CONDENSER, CM-3, MCHX, VENTURI ASSEMBLY

TAC-SER07-001
01-25-07

SUBJECT: NEW CONDENSER COIL DESIGN

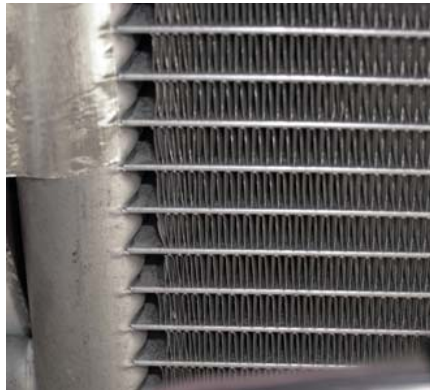
Carrier Transport Air Conditioning has introduced a new "Micro-Channel Heat Exchanger" (MCHX) condenser coil into the skirt-mounted CM-3 & CM-2 series condensers. The construction and appearance of this new coil is similar to the radiator and air conditioning coils found in most automotive applications.

As shown in the above illustration, the micro-channel condenser construction is different than what you have seen and serviced in the past.

The MCHX coil is more open and therefore much easier to clean compared to the RTPF coils.

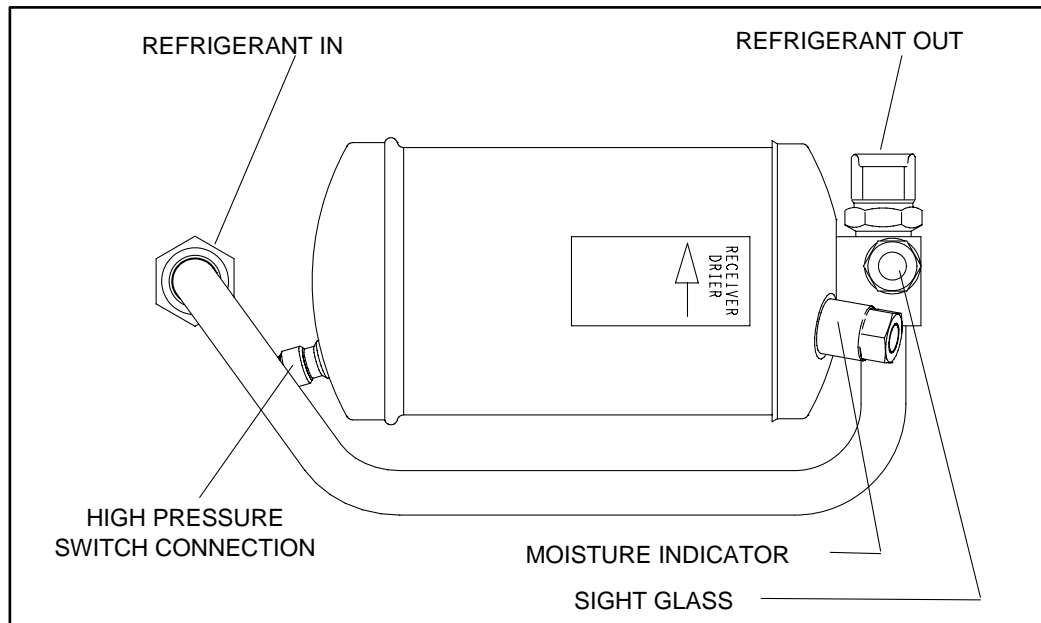
The heat exchange rate of a MCHX coil is higher, resulting in lower head pressures, and the internal volume is lower, resulting in less charge. Also, to ensure sufficient liquid refrigerant volume for differing operating conditions, MCHX units are fitted with a new receiver/dryer assembly. This new component, the shown in the following illustration, has the ability to store the required reserve liquid.

Under no circumstances should the installed receiver/dryer be valved off, or replaced with a conventional filter-dryer as it is specifically designed to store the reserve refrigerant. In addition, the High Pressure Safety Switch must be re-installed on the replacement receiver/dryer in order to prevent system damage and possible injury. If the system is serviced, the receiver/dryer is to be replaced in the same manner as the original dryer. These are available from service parts as P/N 65-00193-00.
